FORM P2: SITE PLAN ADMINISTRATIVE – Development Facilitation Team (DFT) as of 12/25/2022 **SITE PLAN ADMINISTRATIVE – DFT**

SHEET TITLE
SITE PLAN - EPC, MAJOR AMENDMENT JULY 20, 2023

PROJECT TITLE: **STARBUCKS - TRAMWAY**
200 TRAMWAY BLVD. NE
ALBUQUERQUE, NEW MEXICO 87123
JOB NO.: **SF-TRAMWAY**
PROJECT MANAGER: **DEVIN NGUYEN**
DRAWN BY: **DIN**
SHEET TITLE: **SITE PLAN**

Site Plan-EPC Major Amendment July 20, 2023: Amended Overall Landscape Plan

SHEET:
A201-B

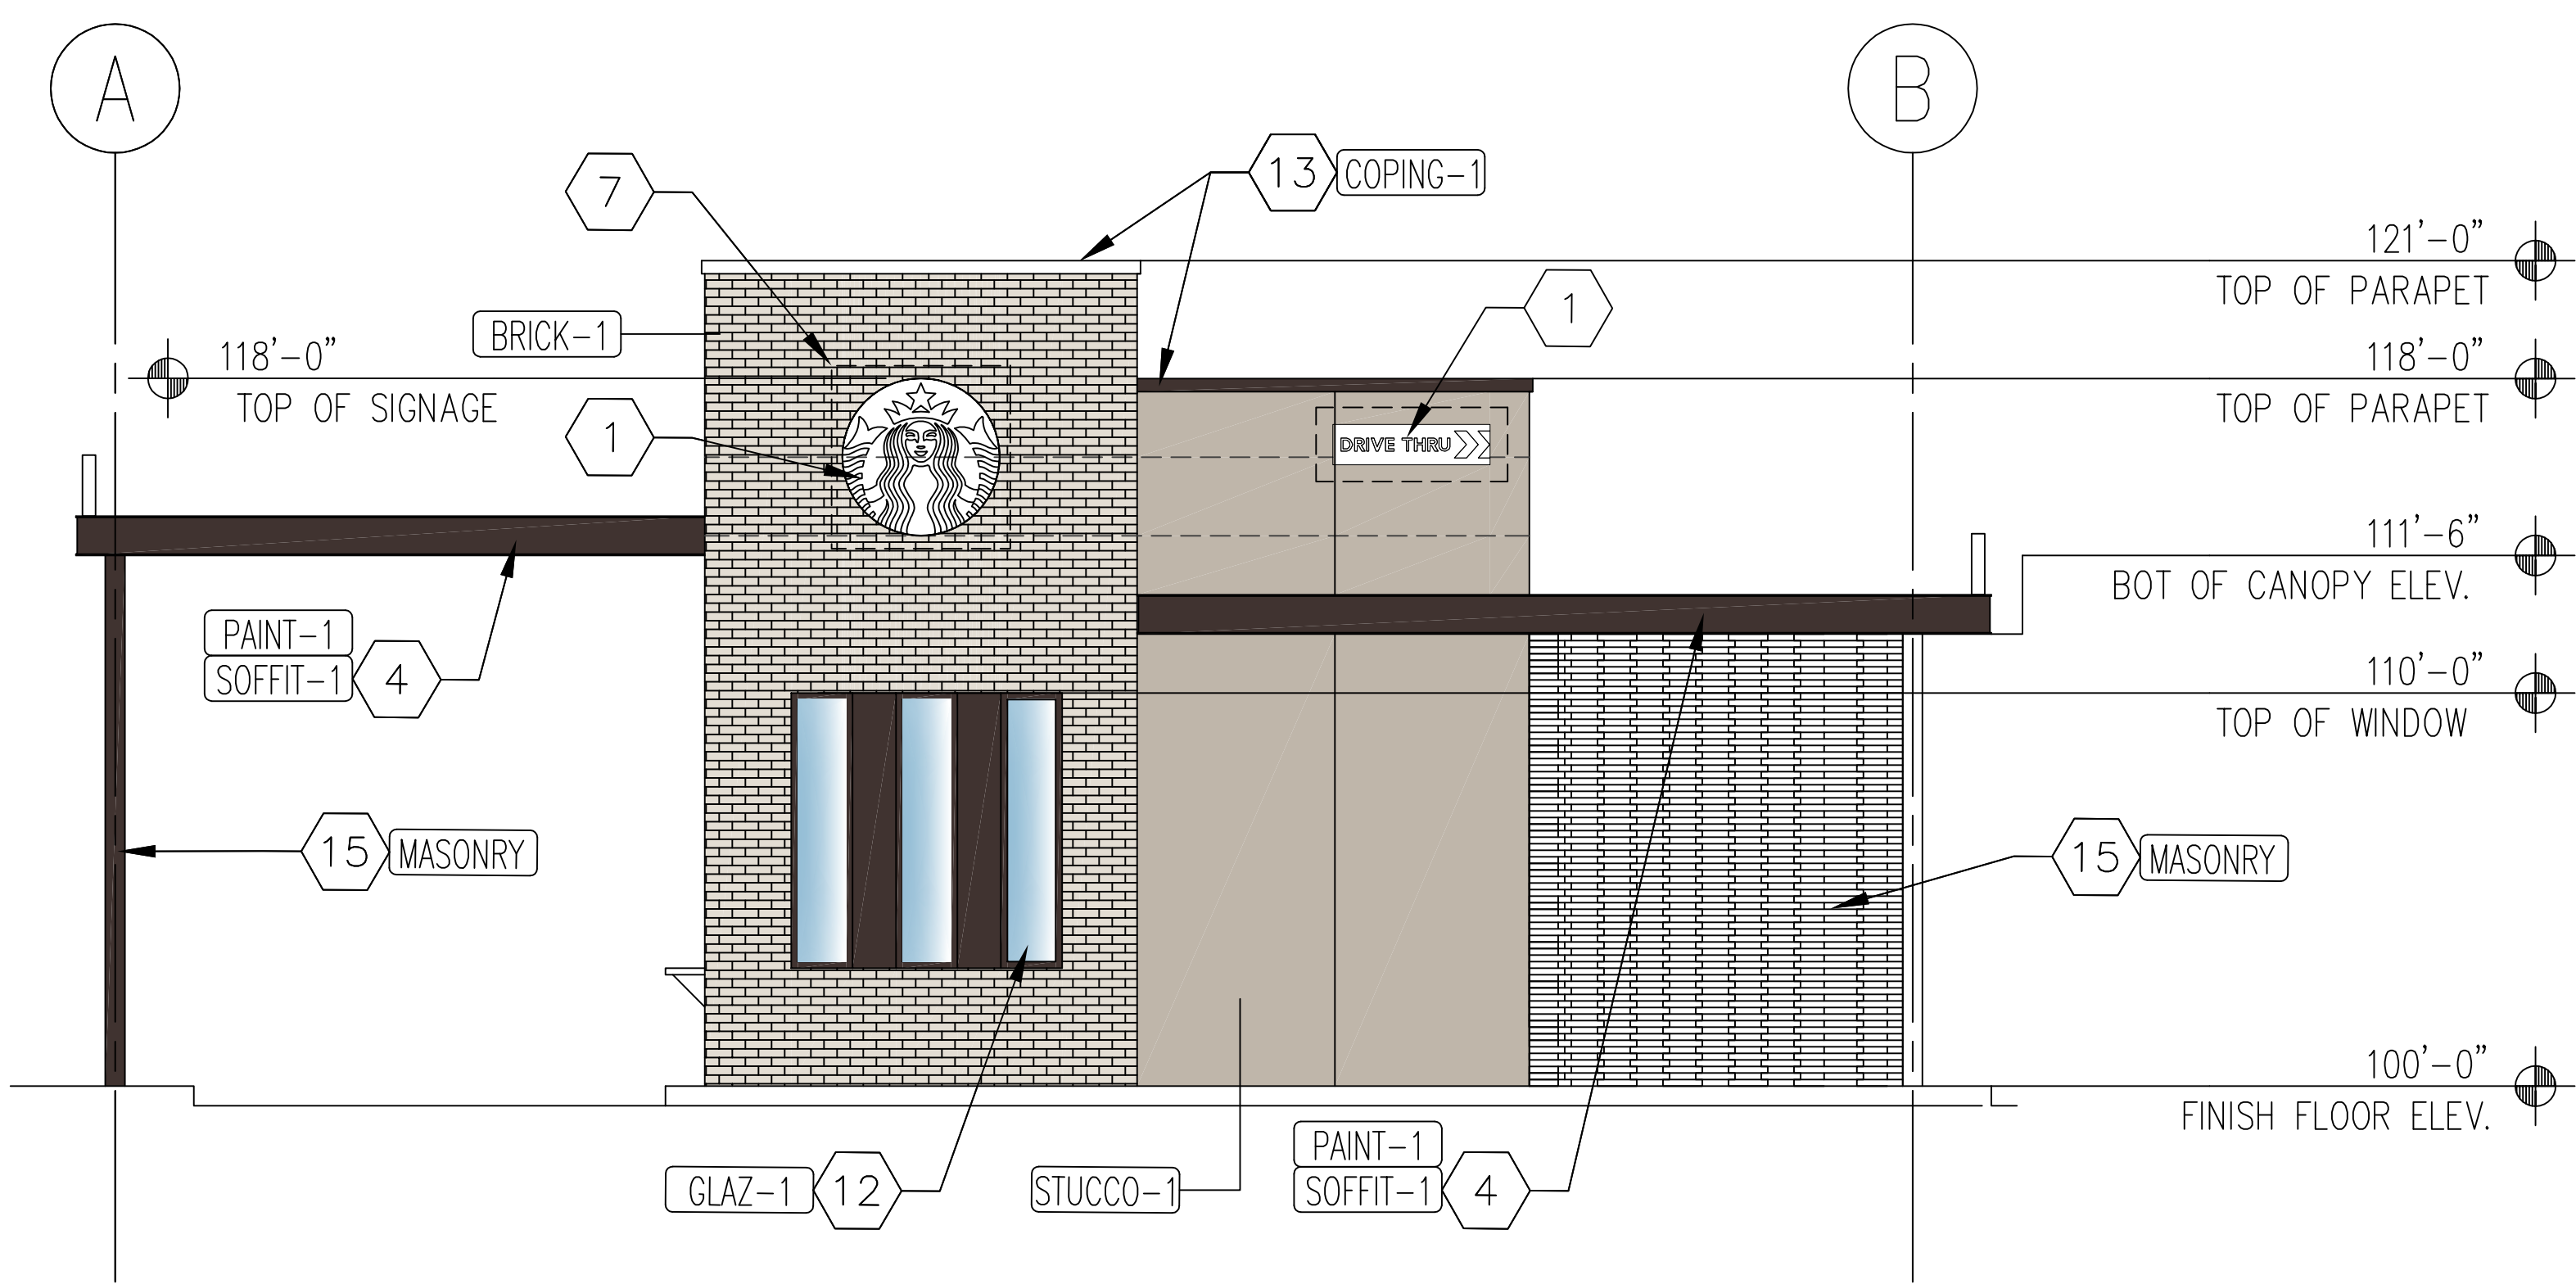
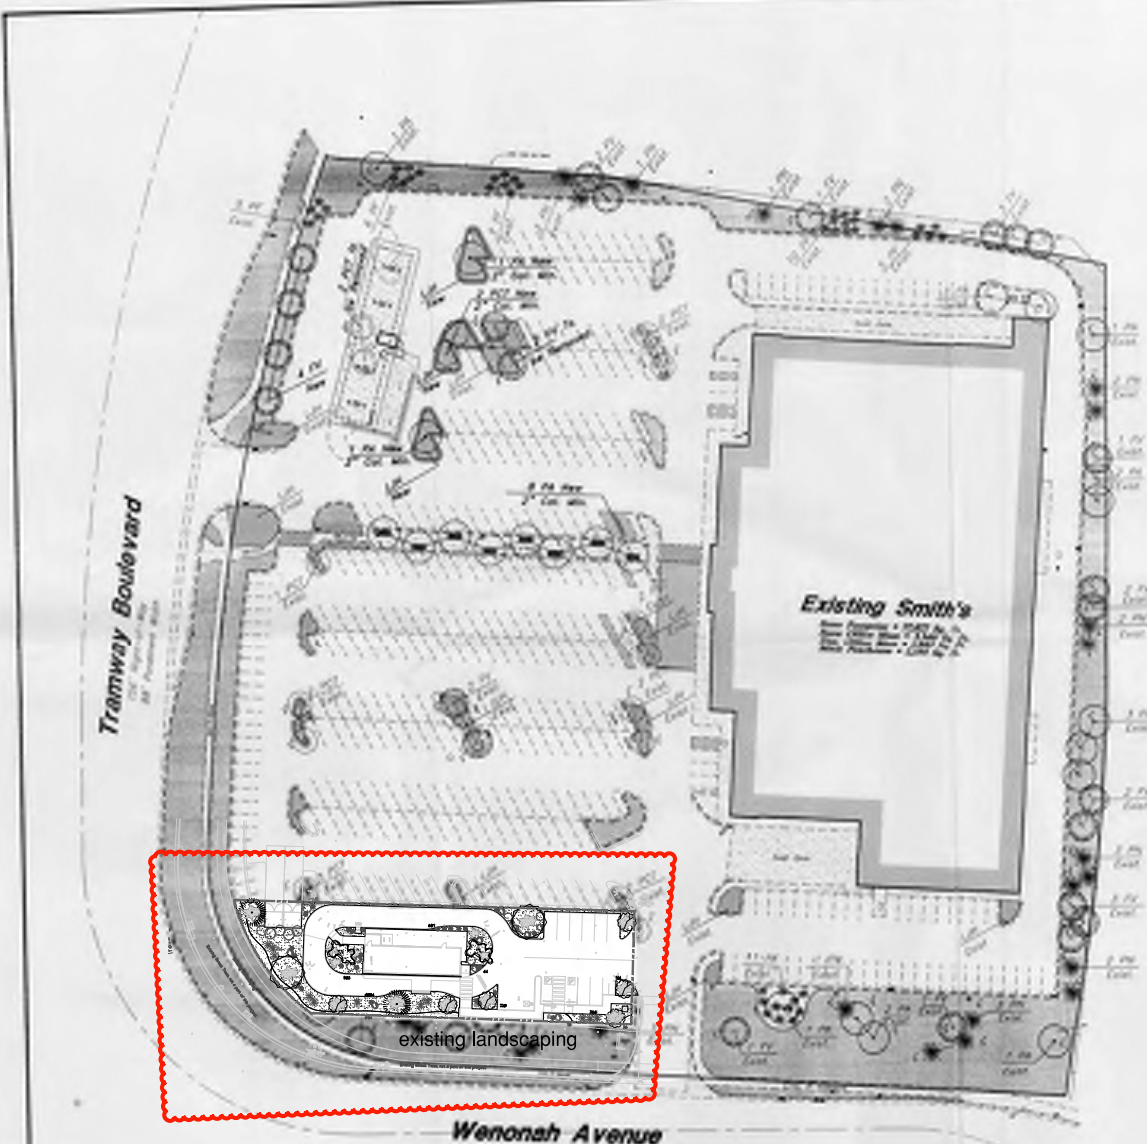
7. Signage:
 - a. All signs shall be included on the elevations of the proposed building.
 - i. **Applicant Response: Refer to sheet A201-A and A201-B for signage locations.**

- b. Dimensions, colors and materials shall be provided prior to submitting to the DFT.
 - i. **Applicant Response: Refer to sheet A201-A and A201-B for Signage Data Table for requested information. The following note have been added to the elevation plans "**Signs will be permitted separately and the colors and material will be determined at the time of sign permit".**

8. Detail Sheets: Colors and materials shall be provided for all details.
 - a. **Applicant Response: Refer to Exterior Materials Table on sheet A201-A and A201-B, bottom right corner for building materials.**

DATE	SHEET
05 Jul 2023	AS101
SCALE:	AS NOTED

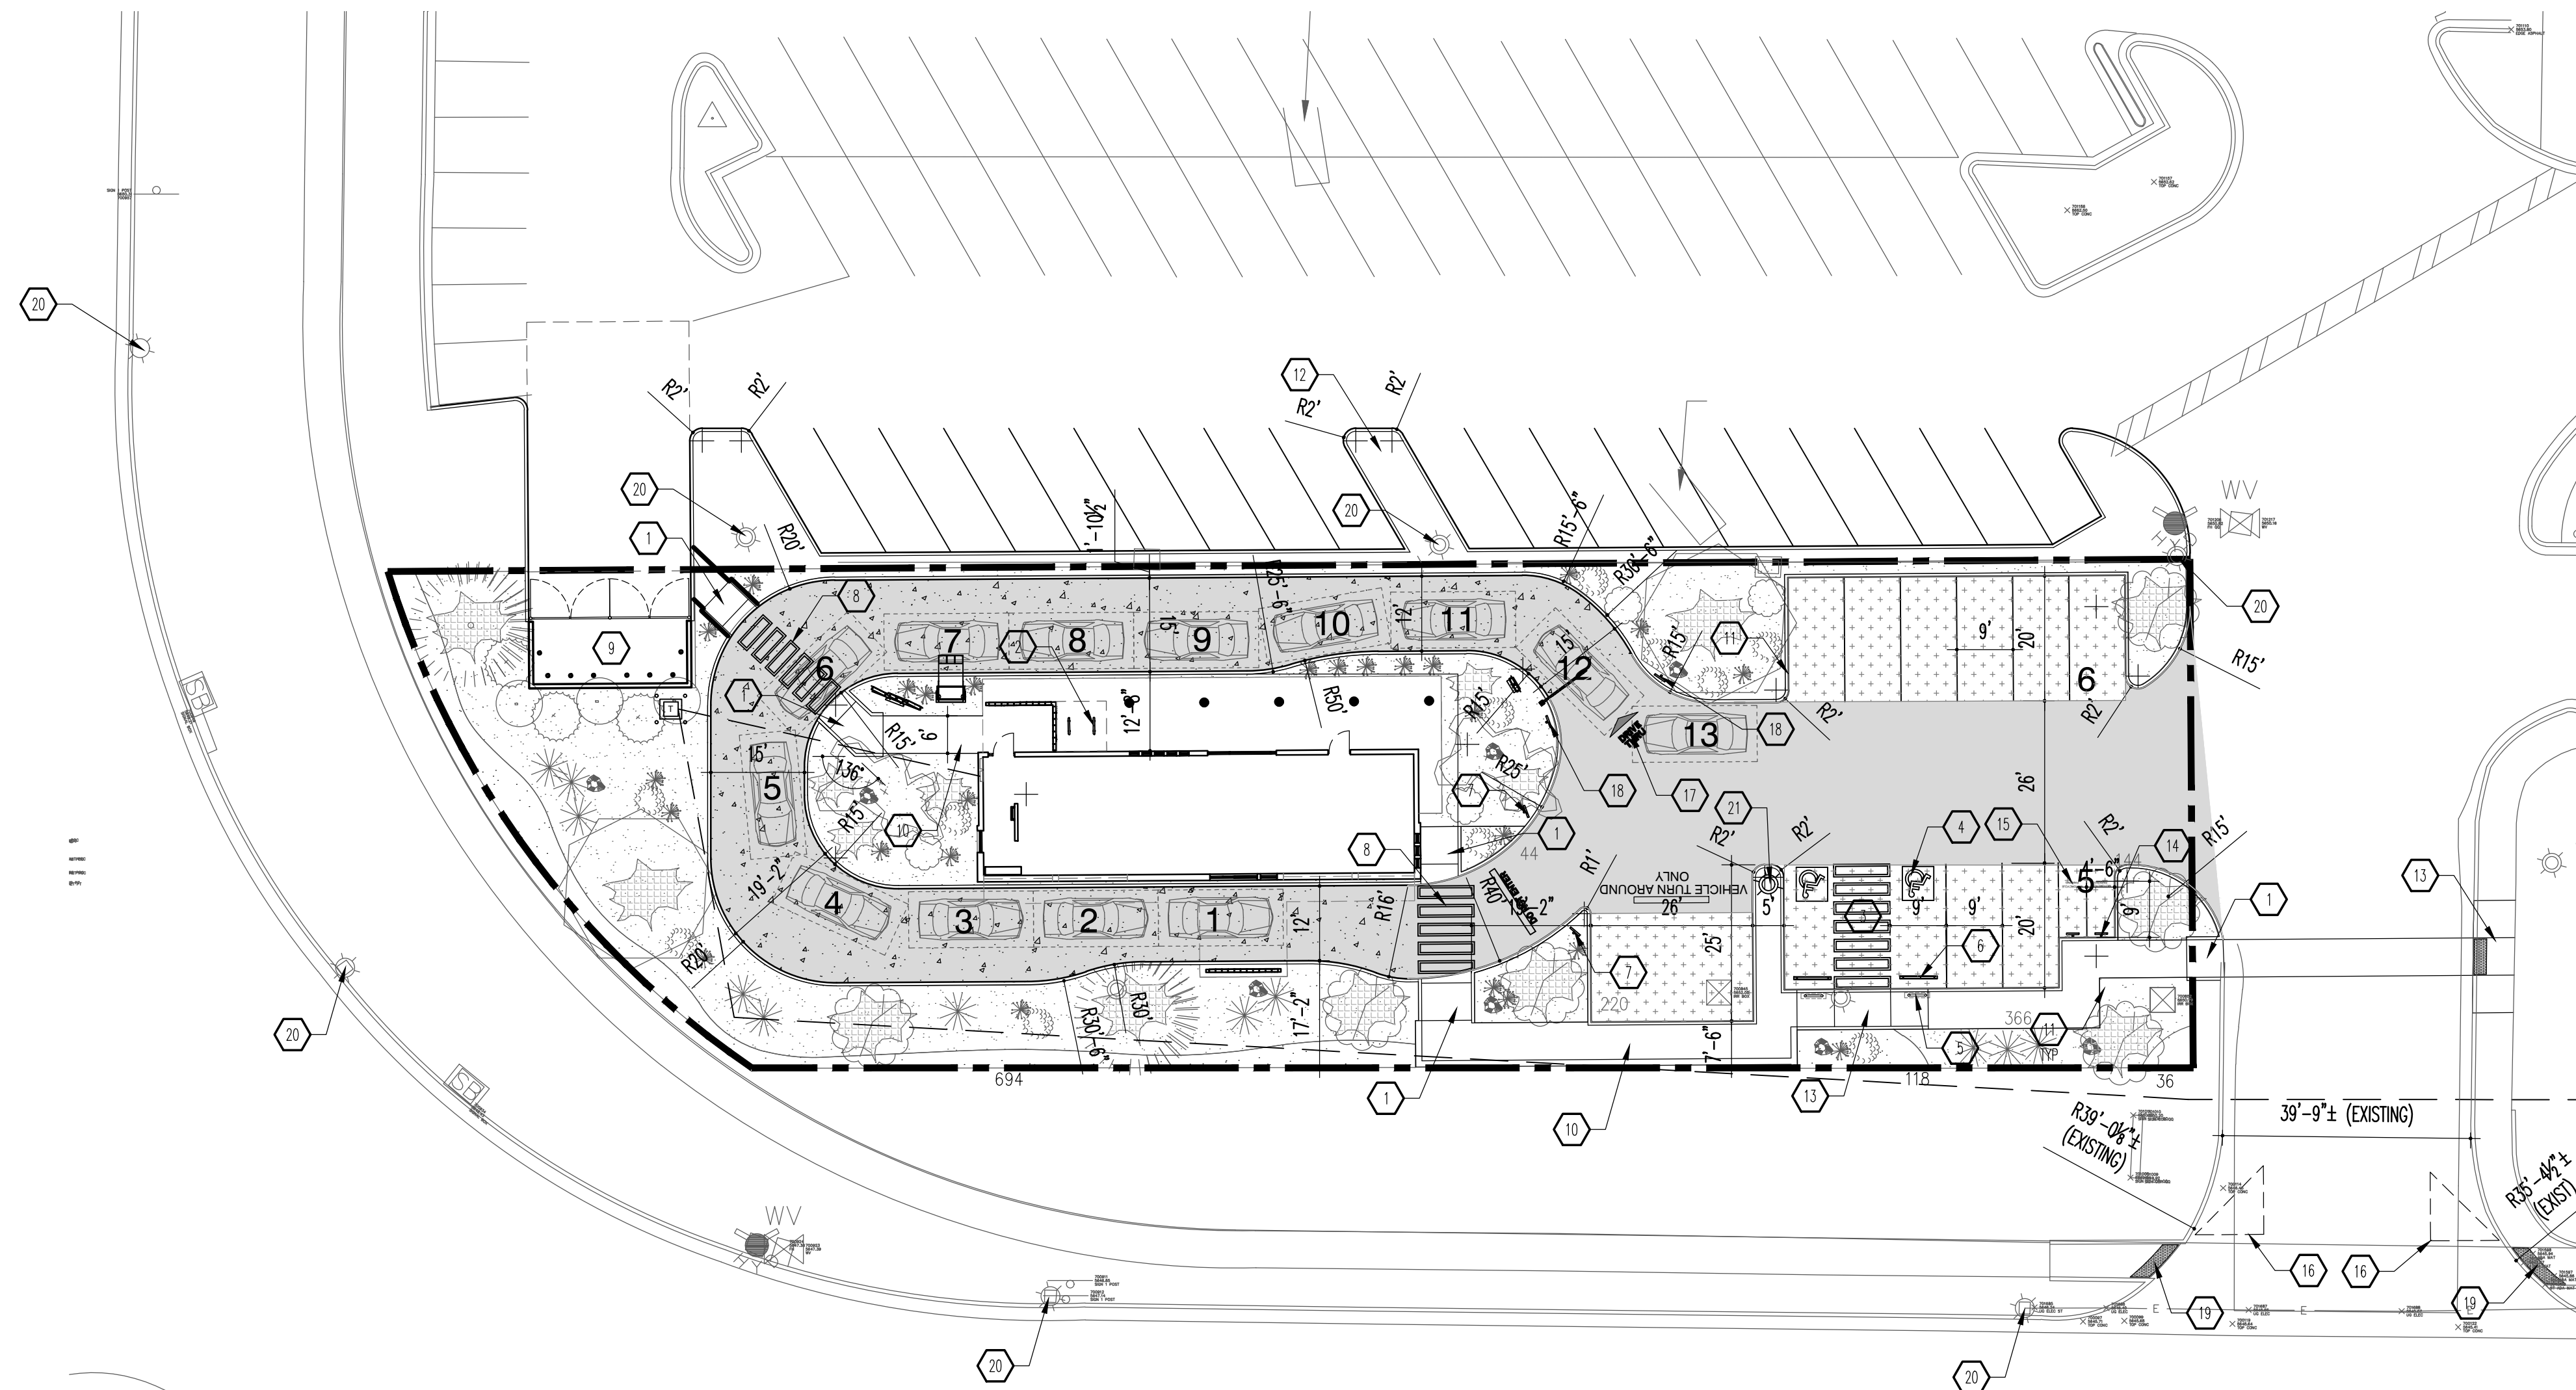
4. Site Plan:
 - a. Provided bicycle parking total shall be added.
 - i. **Applicant Response: A total of (4) bicycle parking space was provided, please see sheet AS101; bottom right corner.**

- b. Light pole locations shall be added to the proposed site plan.
 - i. **Applicant Response: Per sheet AS101, existing light poles are identified (keyed note #20). In addition, we're proposing (1) new light pole to the site (keyed note #21).**

5. On-site walkways and crosswalks shall be identified to motorists and pedestrians pursuant to 5-3(D)(3)(c) Materials to Alert Motorists
 - a. **Applicant Response: On-site walkways and crosswalks are identified on sheet AS101 with reference detail C5/A1.1, A3/A1.2, A5/A1.2; and C5/A1.2 with paving color change per 5-3(D)(3)(c) requirements.**
